RFP Title: Classical High School Campus Electrical Upgrades

Addendum #: 2

Addendum #2

Project: Classical High School 770 Westminster St., Providence, RI 02903

SHEET NO.
E-101
© 2025 JAED CORPORATION

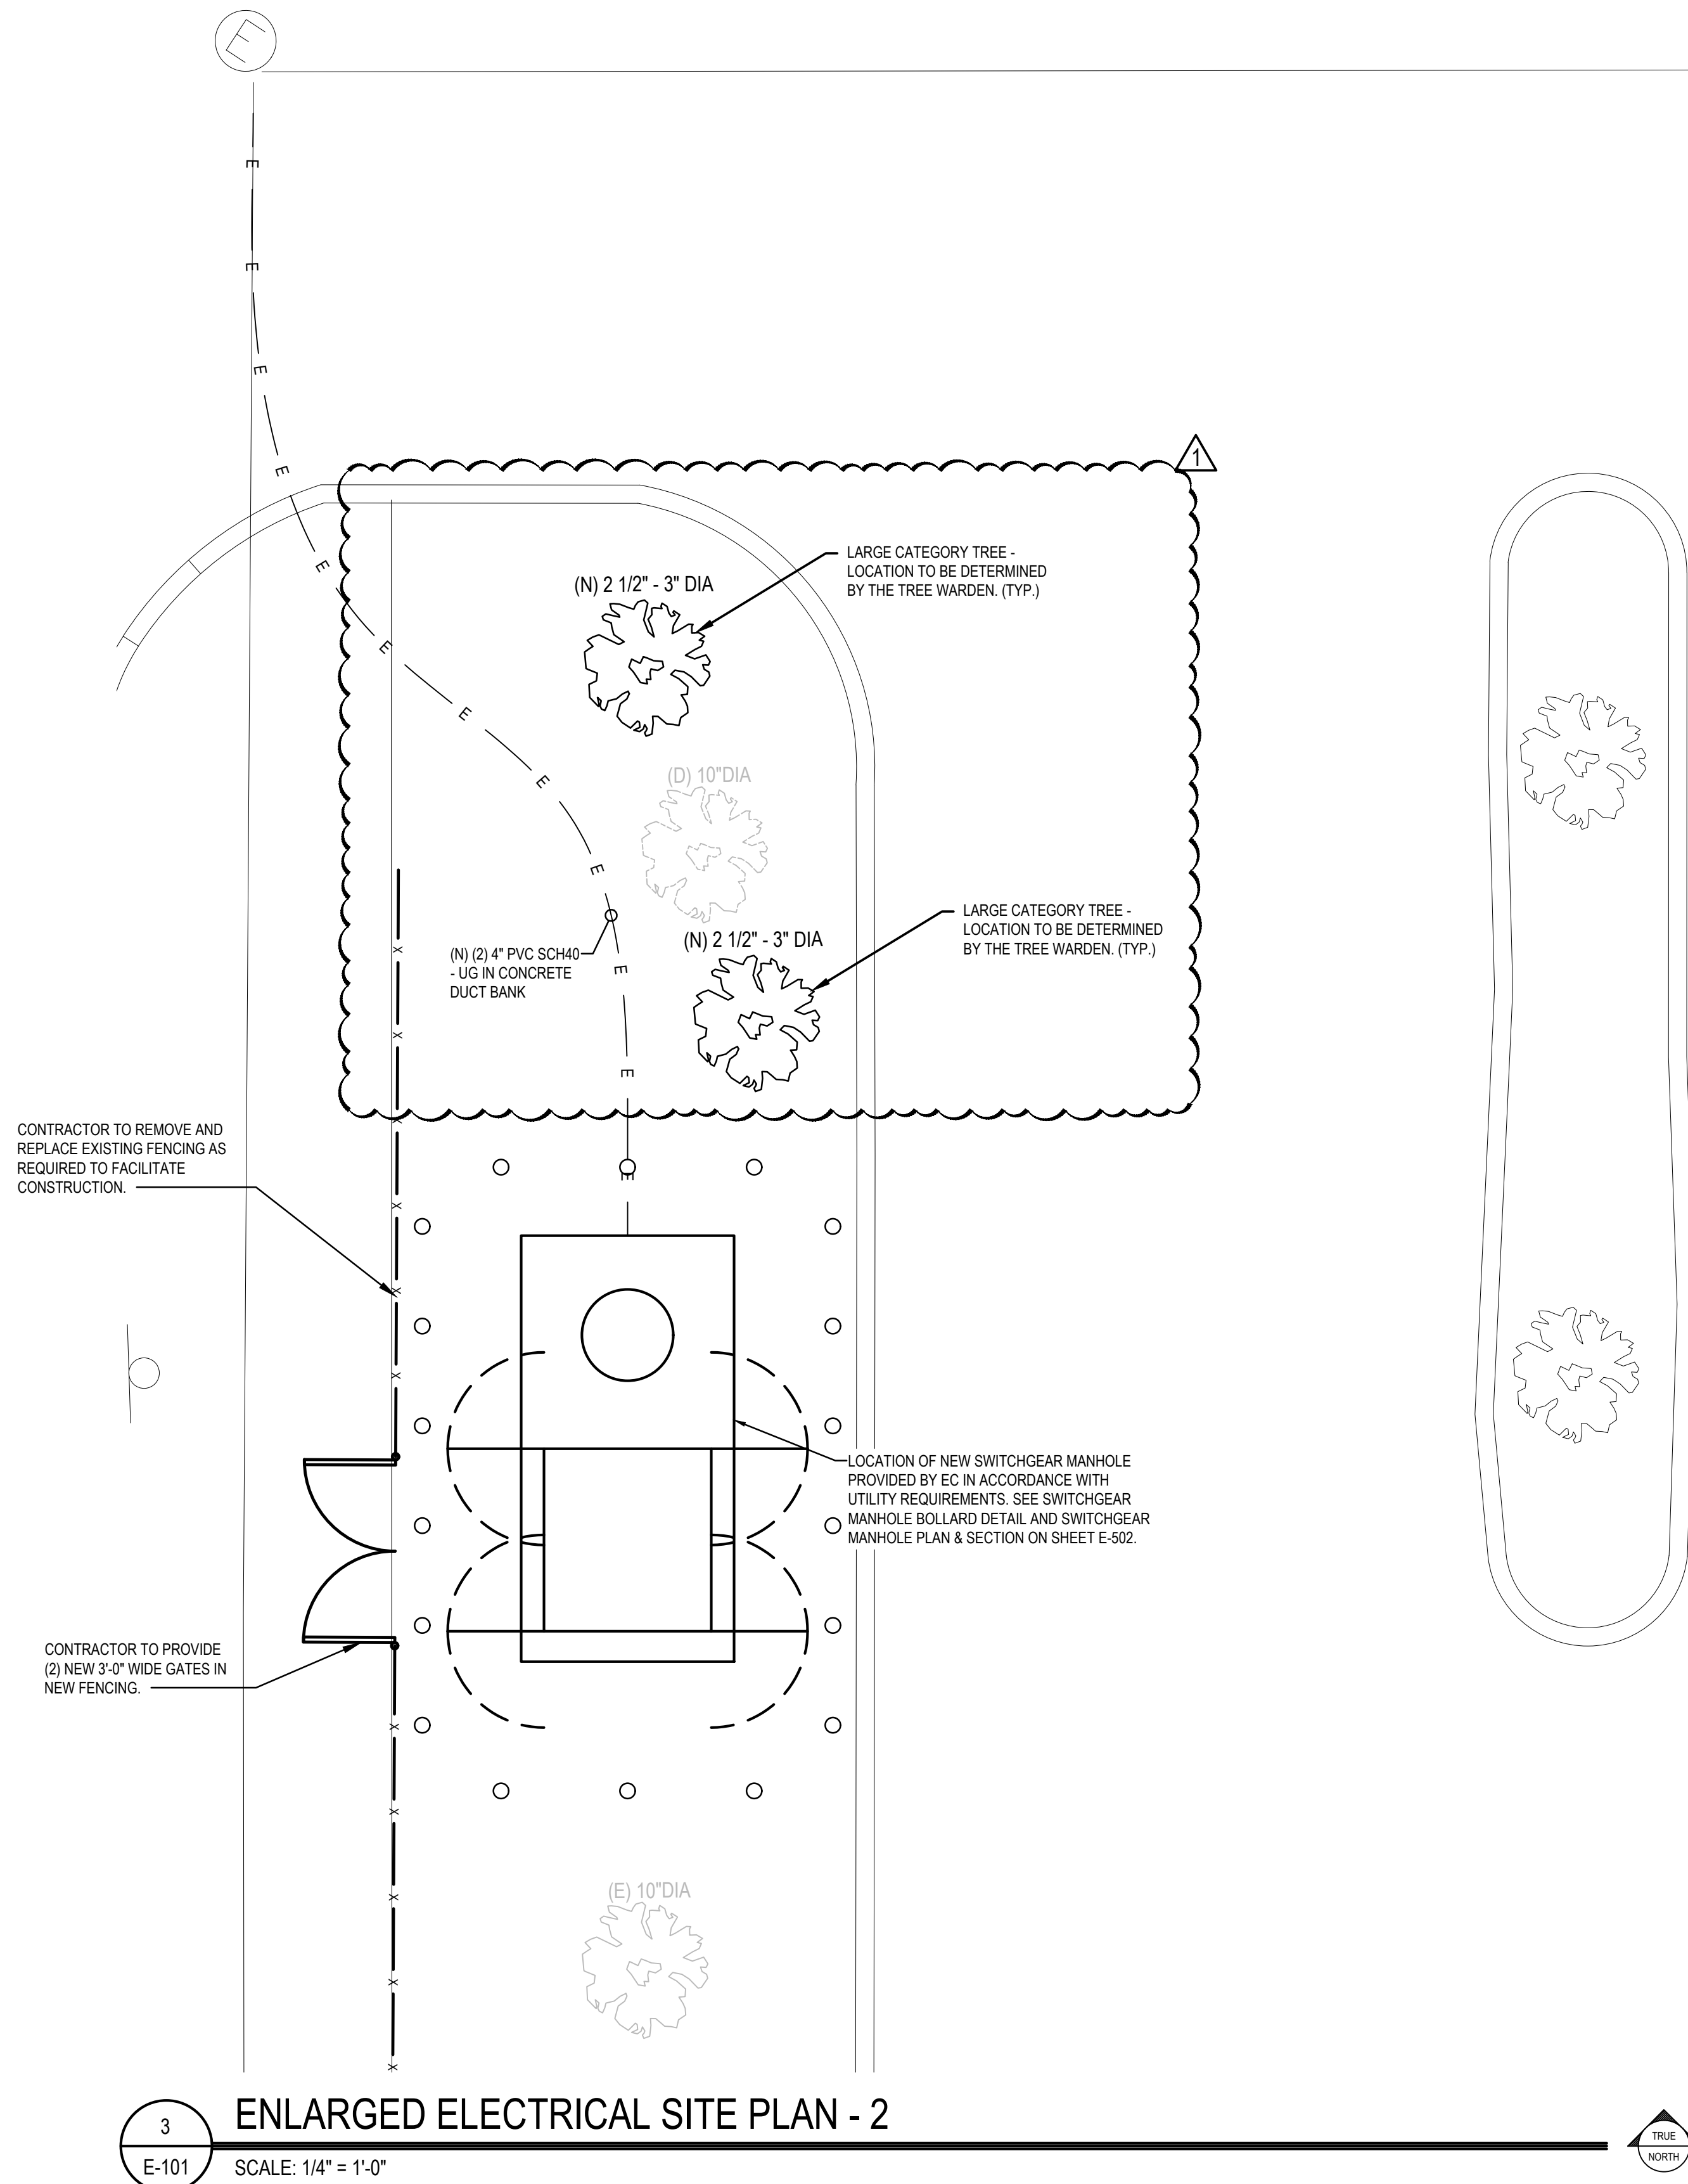
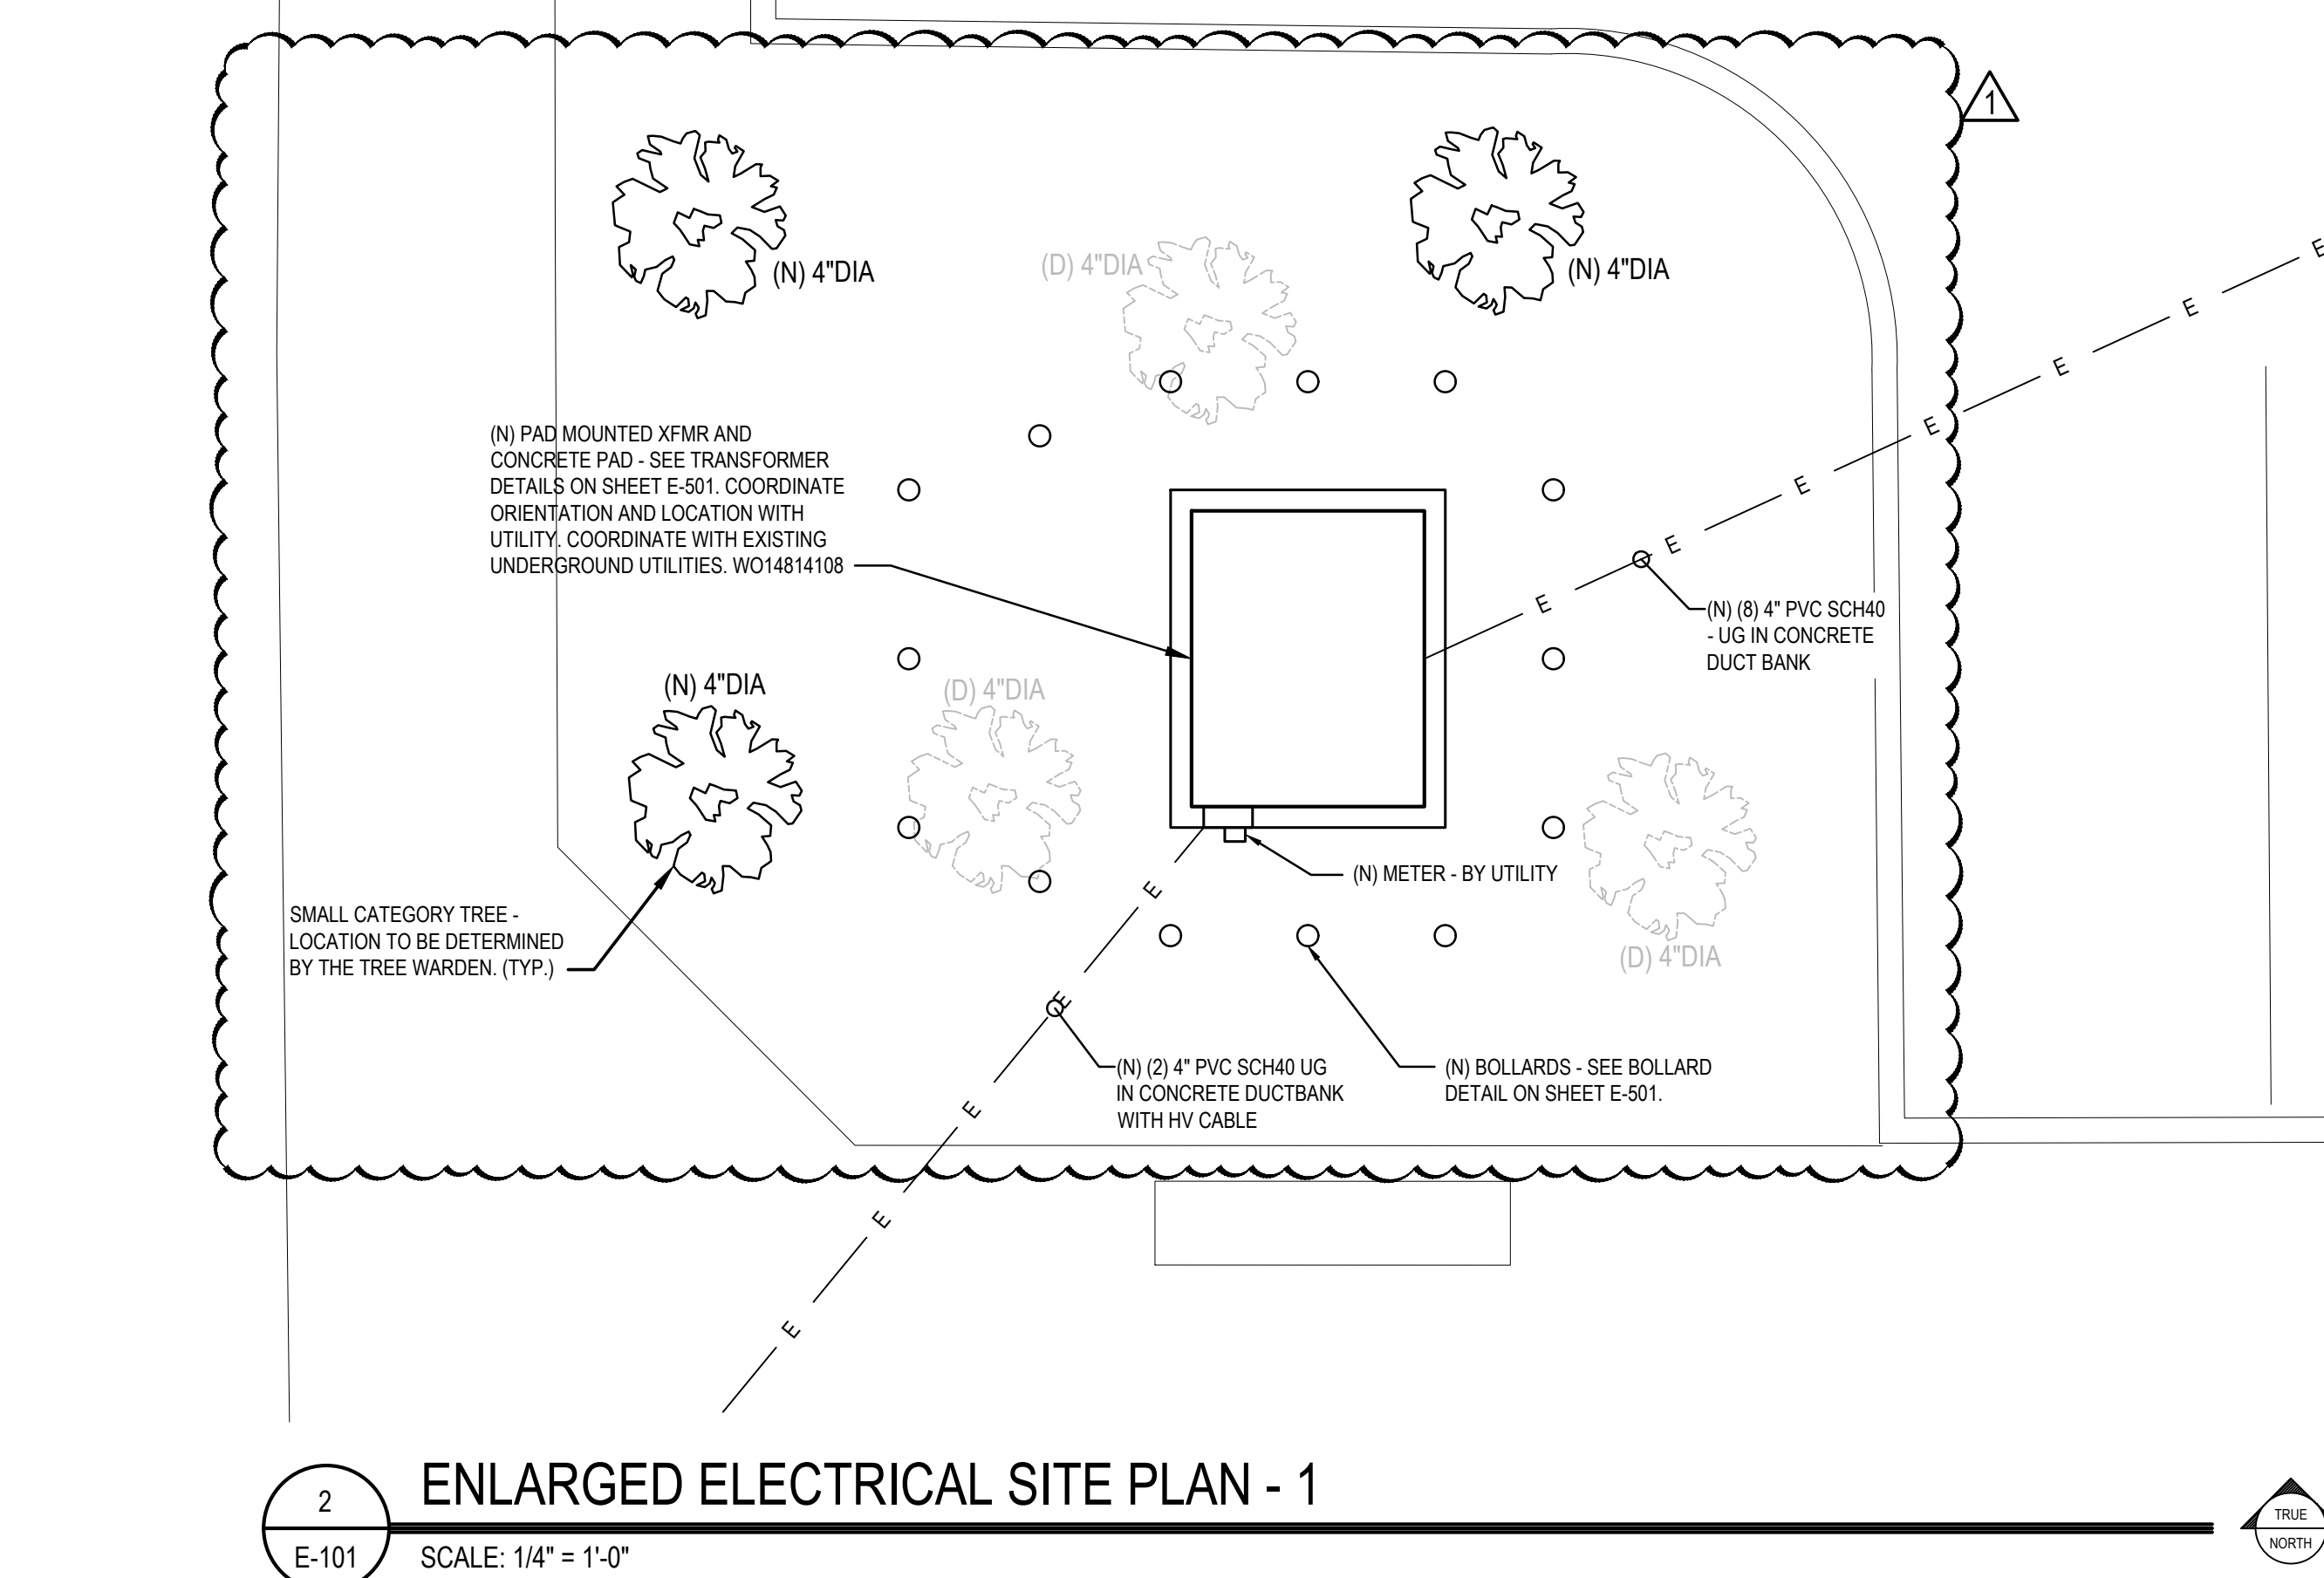
- 1. *Drawing E-101*
 - a. Identified additional scope in Building H.
- 2. *Drawing E-102*
 - a. Moved enlarged plans associated with Building 2 to sheet E-103.
 - b. Added a demolition plan of the basement of Building 1.
 - c. Added a DVR and a new 1200A panel PH1 to the new plan of the basement of Building 1.
- 3. *Drawing E-103*
 - a. Added this sheet.
 - b. Moved enlarged plans of Building 2 to this sheet from E-102.
 - c. Added Building H demolition and construction plans.
 - d. Added pullbox locations to Building 2 plans.
 - e. New housekeeping pad added.
 - f. Added new Distribution Section to **(N) SWBD-1.**
- 4. *Drawing E-502*
 - a. Added the housekeeping pad detail.
- 5. *Drawing ED601*
